# Welsh Subdivision

Pinch Street & Route 14  
Scotland, Connecticut

ENVIRONMENTAL

REPORT

FINAL SUBDIVISION PLAN  
 PREPARED FOR  
 ROBERT WELSH JR.  
 CONN. RTE. NO. 14 PINCH STREET  
 SCOTLAND CONNECTICUT  
 SCALE: 1" = 100' APRIL 1985

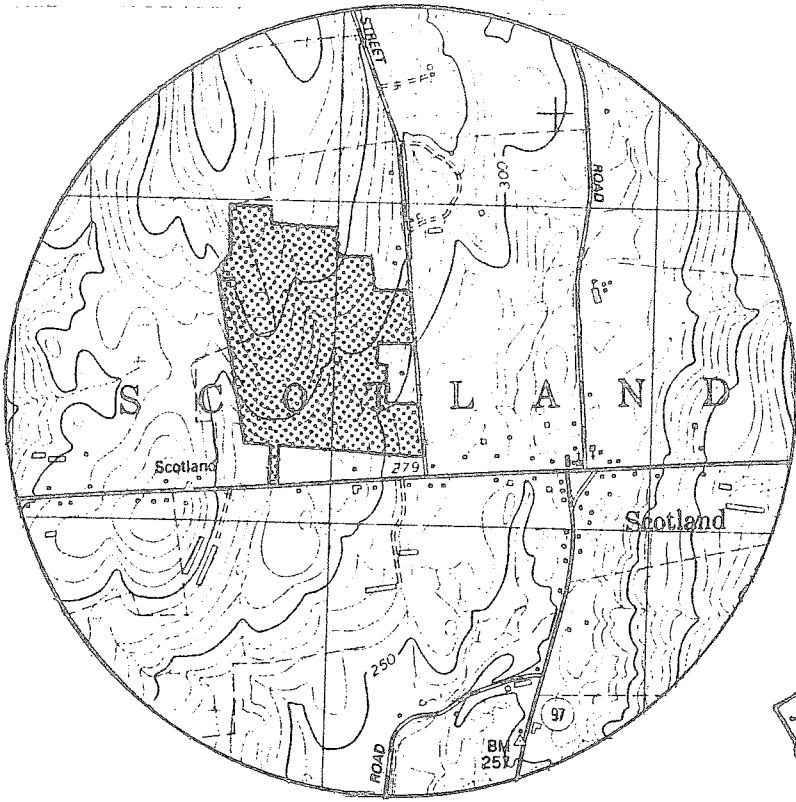
According to deep test pit information, shallow to bedrock areas seem to be restricted to lot 11. (Test pits 21A, 22A, 23 and 26A) Other test pits (24A and 25A) on the lot indicate greater depths to bedrock. Every effort should be made to utilize areas where soils are deeper for the location of the sewage disposal system. Because lot 11 is fairly large in size, perhaps more deep test pits could be excavated in an attempt to find pockets of deeper soils. Perhaps further testing near test pits 24A and 25A, which revealed deeper pockets of soil (5' and 6'), might be worthwhile.

Permanently wet areas in the front portions of lots 9 and 10 consist of silt, clay, sand and a high percentage of decayed organic material. Standing water is present for much of the year in these areas. These areas are inappropriate for any type of development including septic systems. Under the present plans, access drives to lots 9 and 10 are presently proposed along the southern boundaries of each lot and will need to pass over the permanently wet areas mentioned above. Wetland road crossing are feasible, provided they are properly engineered. Based on present plans, it does not appear that any brooks will need to be crossed. However, if the house locations on lots 1, 3 and 4 are located west of the streamcourse, bisecting the lots, the need to cross it will be necessary. When crossing a brook, it is important to install culverts under the road that are properly sized to handle stormwater runoff during peak storms

Access drives to lots 1 through 8 will need to climb relatively steep grades, as steep as 20% entering lot 6. And on rear lots 1, 3, 4, 6, 7, 8 driveways will be 500-600 feet long. Long drives with areas of steep inclines offer serious erosion potential, erosion of soil and/or gravel fill - down into Pinch Street. Careful layout of drives with water breaks to intercept and spread storm runoff into the woods, and stabilized cuts and fills will be important. Subsurface drainage tile may be needed as well to intercept hillside seepage. The layout and design of drives should be part of an Erosion and Sediment Control (ESC) Plan.

As the lots are presently laid out, the stream and associated wetlands crossing the rear of lots 1, 3, 4, 7, and 8 should not propose a problem. However, the stream and greater wetlands on lots 9 and 10 do present limitations. The front of these lots have the potential to flood, and uphill runoff into the middle (from wetlands spot in lot 8) and rear of lot 9 offer problems. If lot 9 is to be used, muck needs to be removed near the road before a drive is developed on fill. And a designed swale needs to be installed parallel with the drive up to lot 8.\* The drive to lot 9 should be as high as the road to prevent possible flooding over in the event of a major storm.

The driveway into lot 10 could be moved away from the well slightly to lessen a potential threat to it. Again, as with lot 9, the drive would need to be filled to the road elevation.

\* A culvert could be placed under the drive to lot 8 allowing flow into this swale. Careful grading behind a house on lot 8 may be needed to prevent a full flowing stream from coming into a backyard.

Proposed well locations shown on lots 4, 8, and 11 should be relocated so that the 75' setback distance required around the well does not fall into adjacent lots. No statute requires this, but it is a proper planning technique.

SURFICIAL GEOLOGY

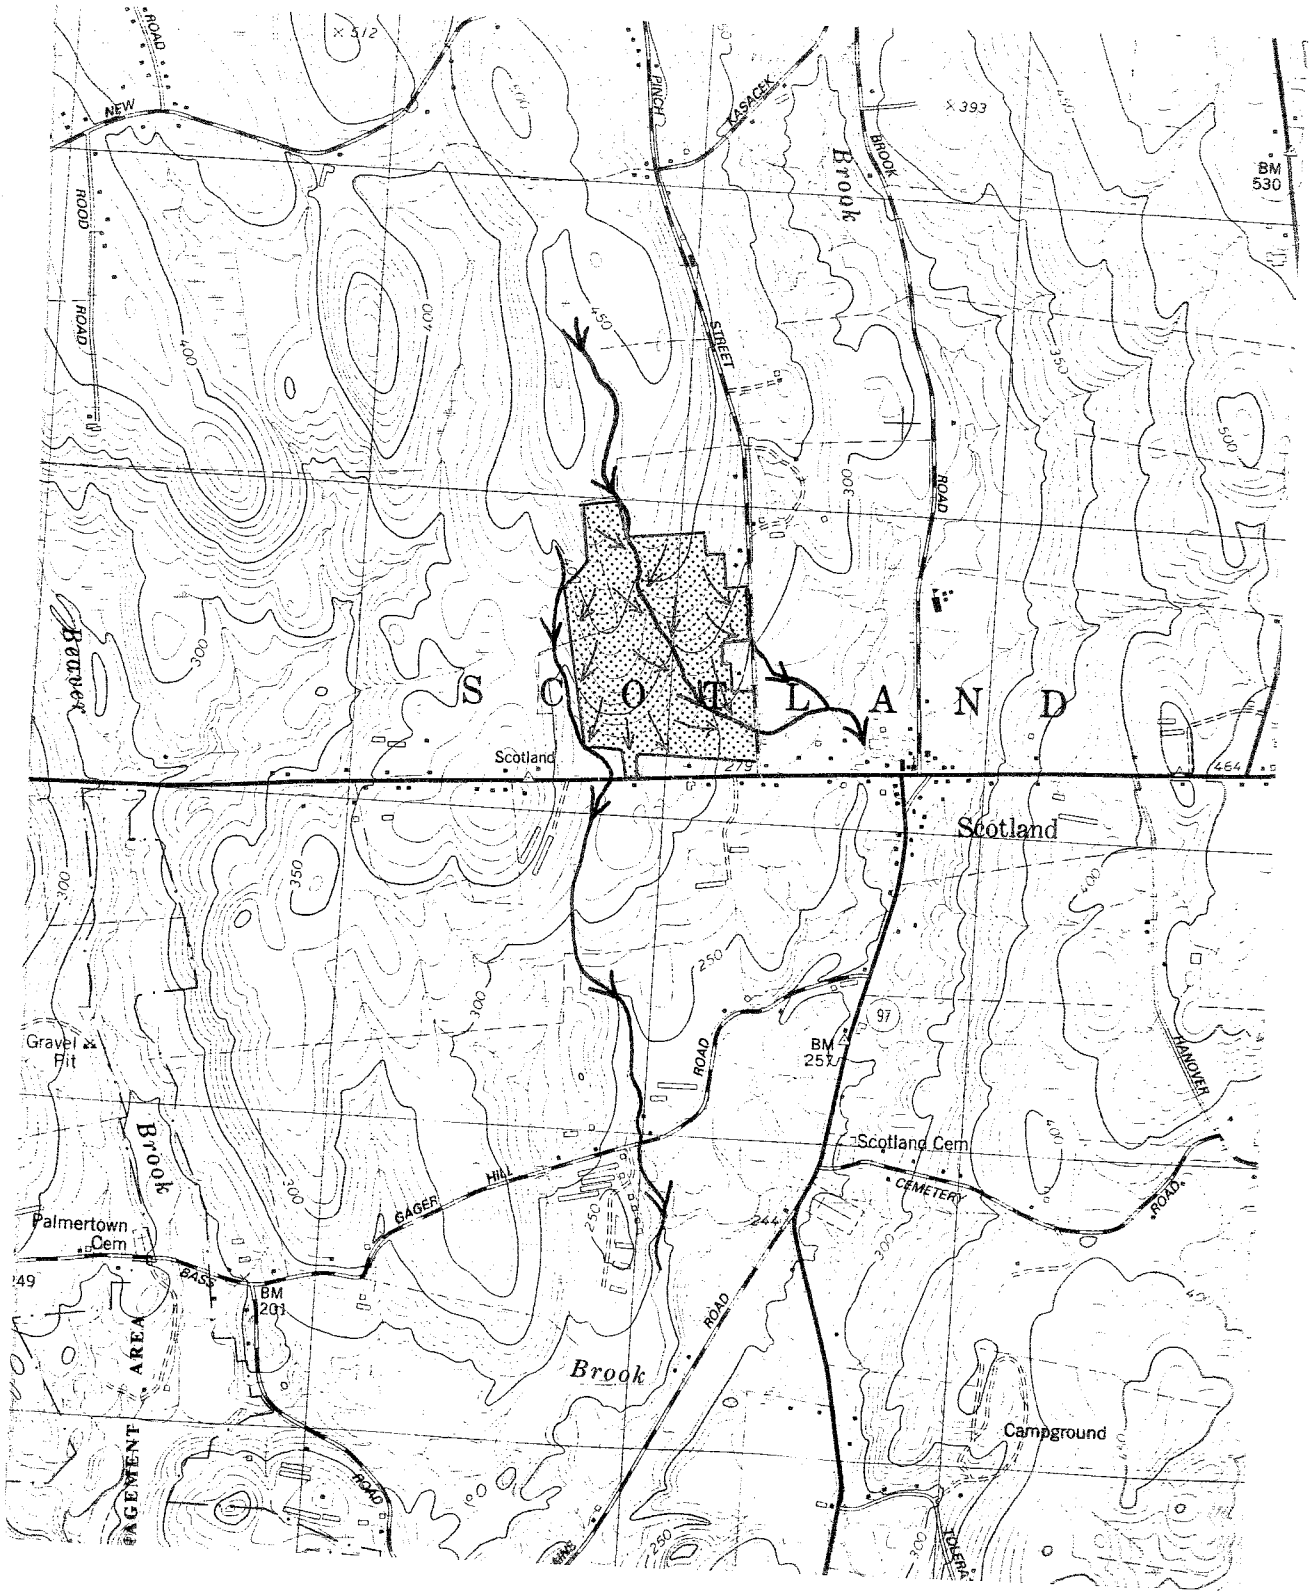
The major geologic limitation of the parcel is the presence of a seasonally high groundwater table. Other geologic limitations which may be a hindrance in terms of developing the site include: (1) moderate slopes on lots 2 and 5, especially in the front portions; (2) the presence of shallow bedrock on lot 11; and (3) the permanently wet areas on lots 9 and 10.

S O I L S

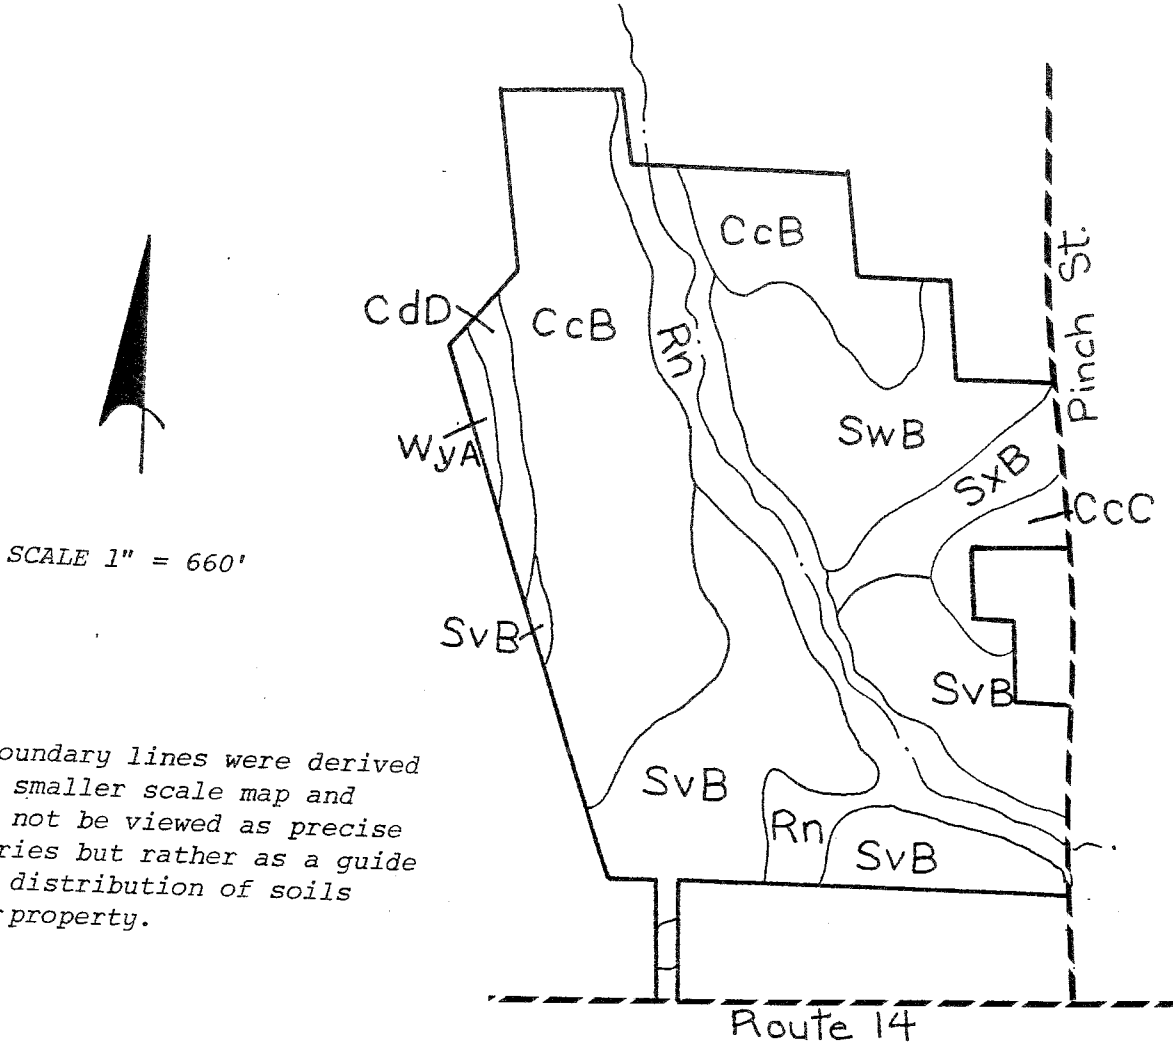
are moderately well drained. A seasonal higher watertable is present here. The Sutton (SvB) is prime agricultural soil. The stream flowing down through the property is a tributary to Merrick Brook. This stream flows through wetland soils Rn and Ru. These are poorly drained. The Rippowam (Ru) soil is subject to potential flooding seasonally. The rapid permeability in the substratum of this soil offers a hazard of groundwater pollution in areas used for septic tanks. The wetlands soils were flagged in the field and are located on the final subdivision plan dated April 1985. Location and set-backs of houses, wells, septic systems, etc. should be according to the flagged wetlands shown. Again, due to the mapping scale the soil map from the Windham County Soil Survey provides more general soils delineations. The soil map and a Principal Limitations Chart is within this report, as are descriptions of all the soils. (See Appendix)

The Sutton SvB soil is prime ag-land. Some of it is being farmed. Consideration should be given to keeping this area for crop production. For example, could the future owner of lot 11 rent a portion of his lot to a farmer? Or, could this area be retained some other way as open space for agricultural purposes?

# VEGETATION SCOTLAND SUBDIVISION

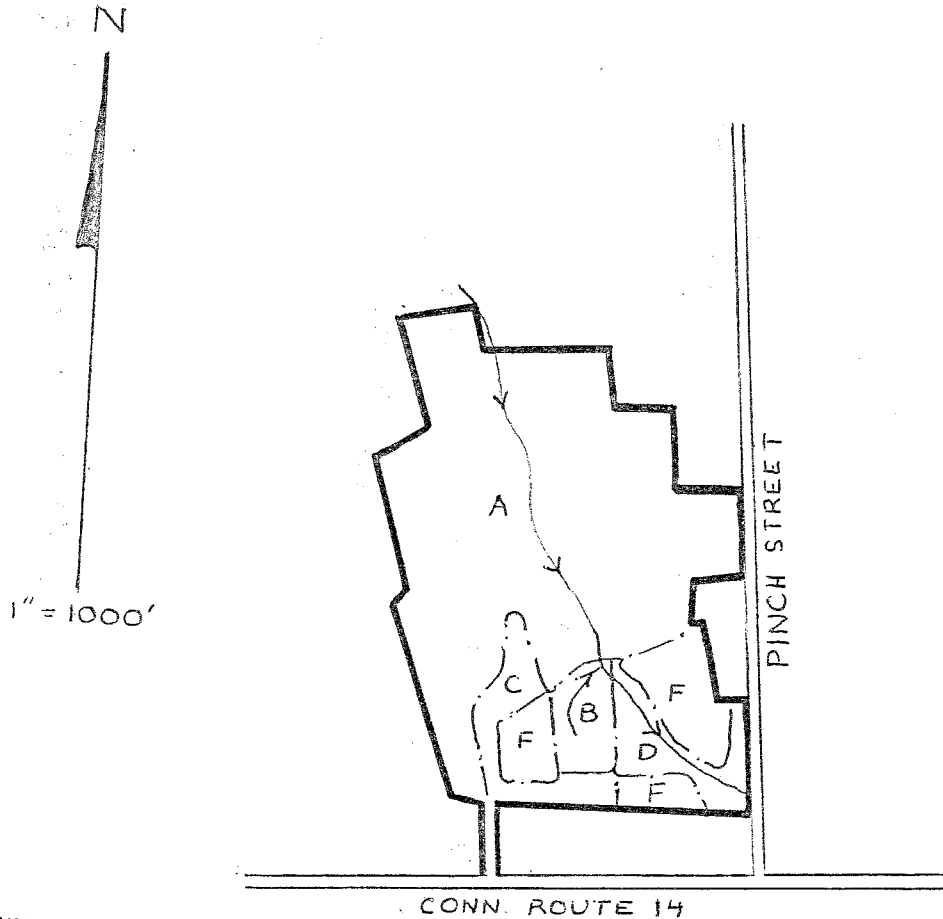
After construction is completed, areas of remaining woodland in Vegetation Type A should be regenerated by group tree selection. Regeneration is warranted because despite the full stocking, the stocking of desirable trees is far below

Vegetation Types C and D would benefit from re-enforcement planting, however, competition from established vegetation would make planting costly and seedling survival poor. Eventually these types will become fully stocked on their own.
